Amendments to the Drawings:

REMARKS

FIGURE 1
PRIOR ART

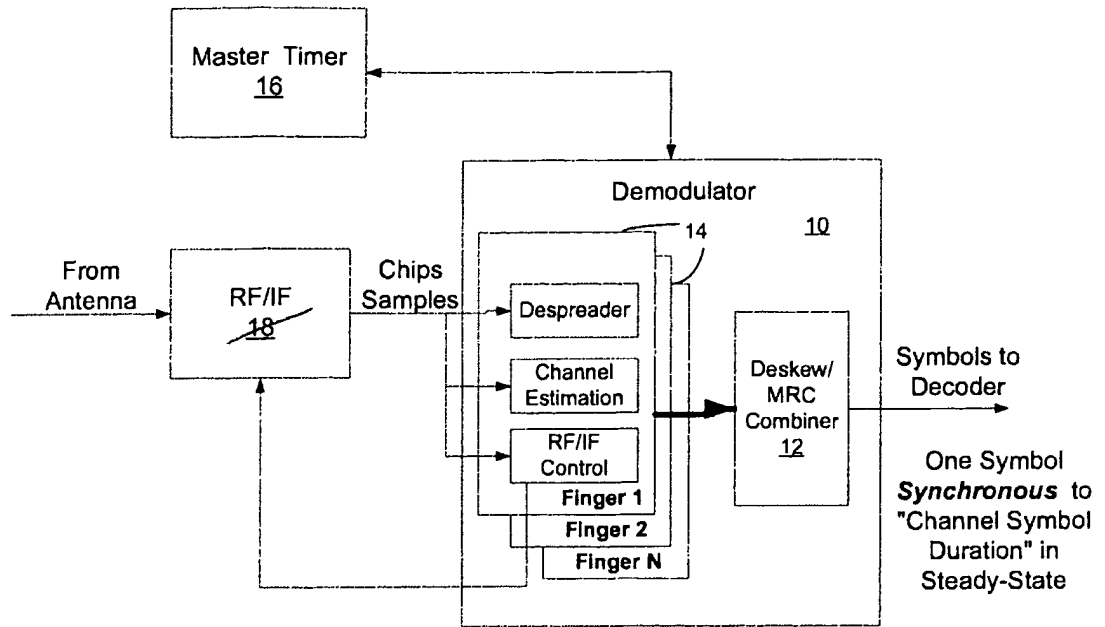
The drawings were objected to for certain informalities. Applicant has submitted herewith new formal drawing sheets to be substituted for previously submitted drawing sheets. With respect to the objections to Figure 1, Applicant respectfully notes that reference character "16" is mentioned in the specification in paragraph [0006].

The drawing sheets attached in connection with the above-identified application containing Figures 1, 4, 7, 14, 18 and 20 are being presented as a new formal drawing sheet or sheets to be substituted for the previously submitted drawing sheet or sheets. All drawing Figures have been amended. Appended to this amendment is an annotated copy of the previous drawing sheet which has been marked to show changes presented in the replacement sheet of the drawing.
